**VE (DI) FUEL-
INJECTION PUMPS**

**Workshop: EP
06.1994
0393 En**

Shutoff problems

KMK03383

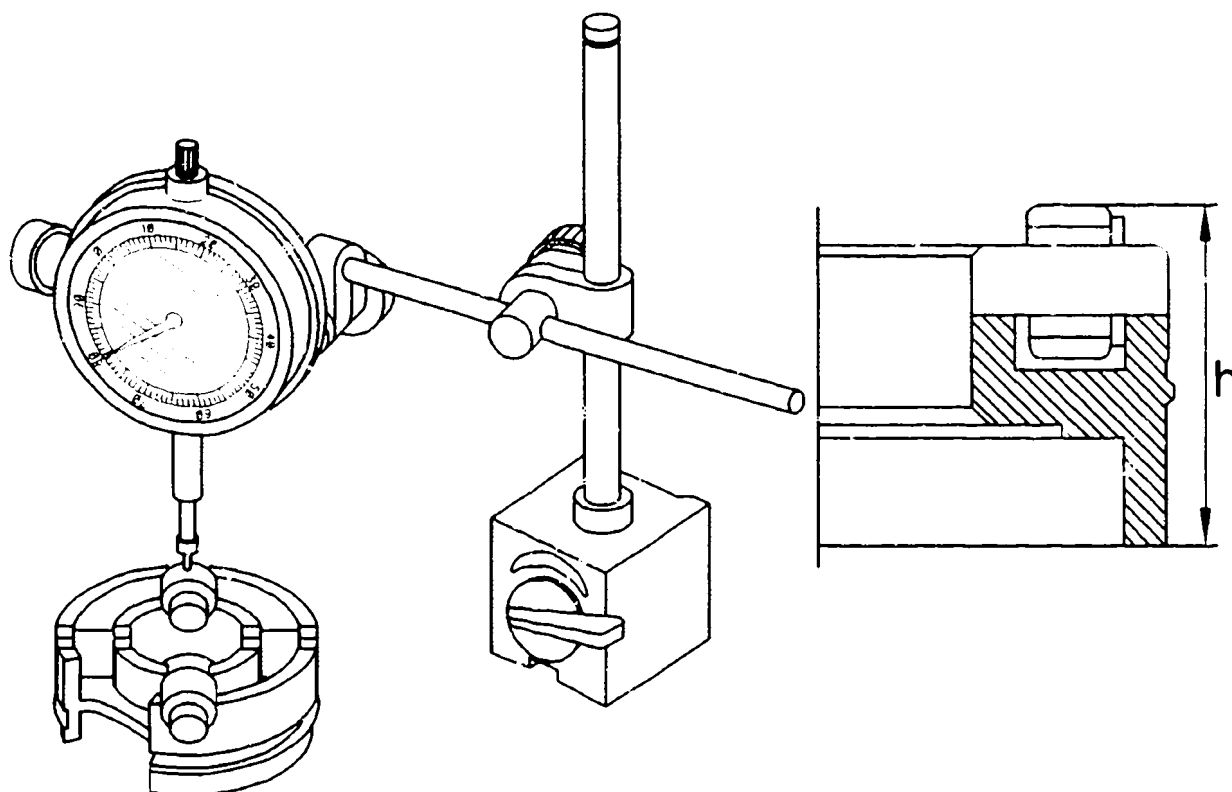
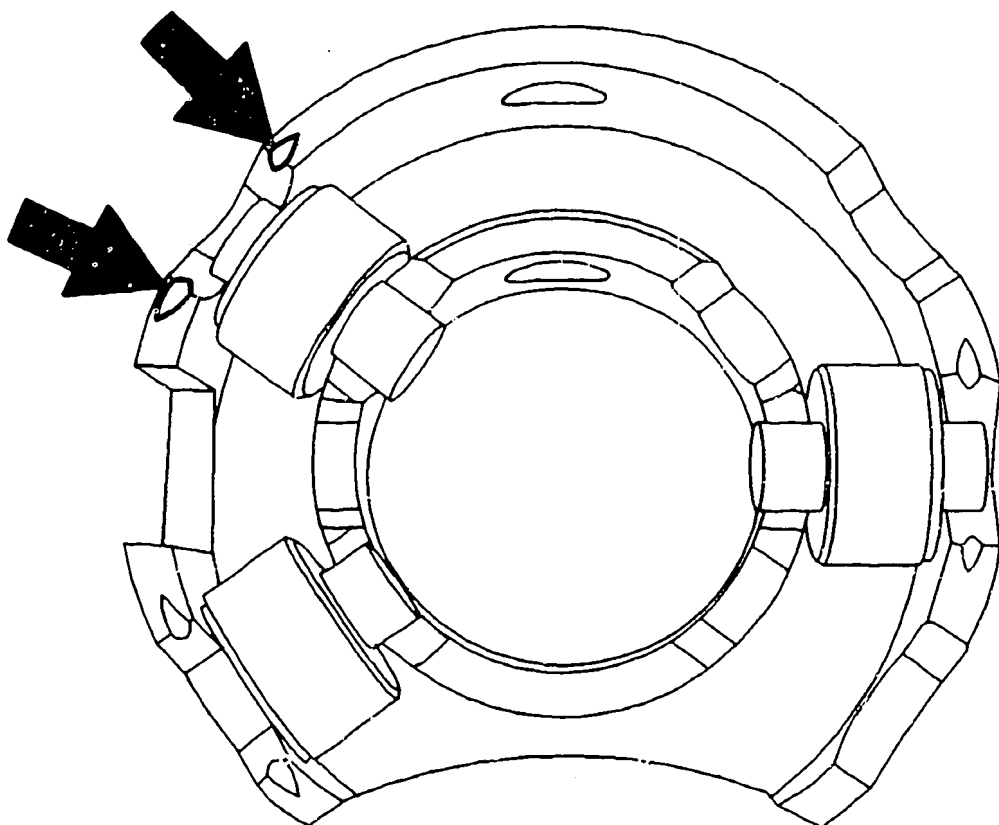
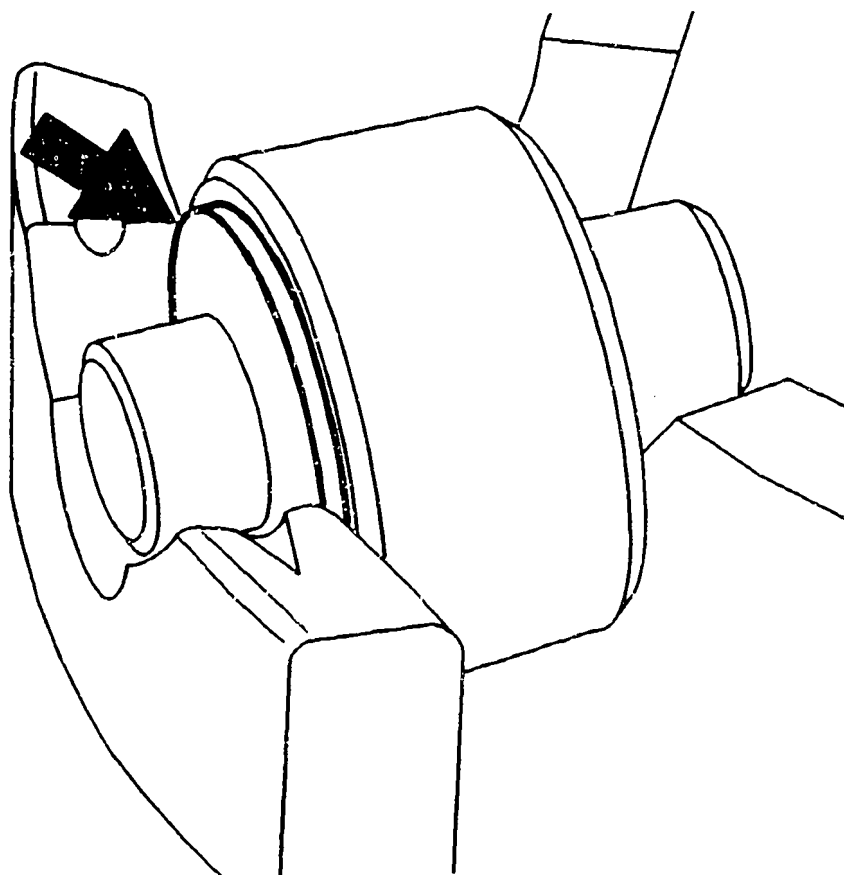
To date, the "cam roller ring" service parts assembly has only been quoted as a complete item in service parts lists and installed as an entity. Technology has now reached a level where it is possible to replace individual rollers, bushings and bearing pins.

\* Maximum difference between individual roller heights 0.04 mm

Bearing grooves into which one roller is to be inserted in each case, are marked by notches (arrows) on the end face of the cam roller ring.

The tapered side must be facing the outer ring.

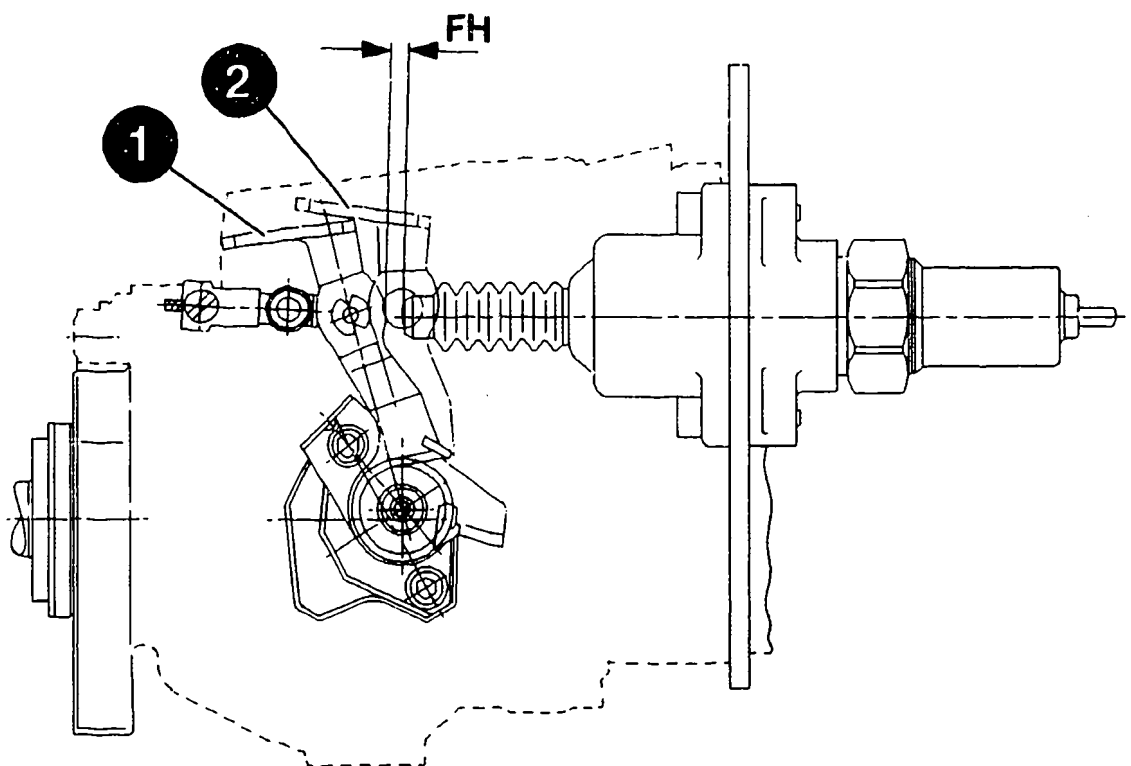
To improve cold starting problems, the  
adjustment travel of the cold start  
acceleration device acting on the  
roller ring is being altered from  
7 mm to 2.9 mm.

In future, the adjustment travel  
for VE pumps with KSB will be given  
in the KD test specification sheet  
under "Functional stroke" (FH).
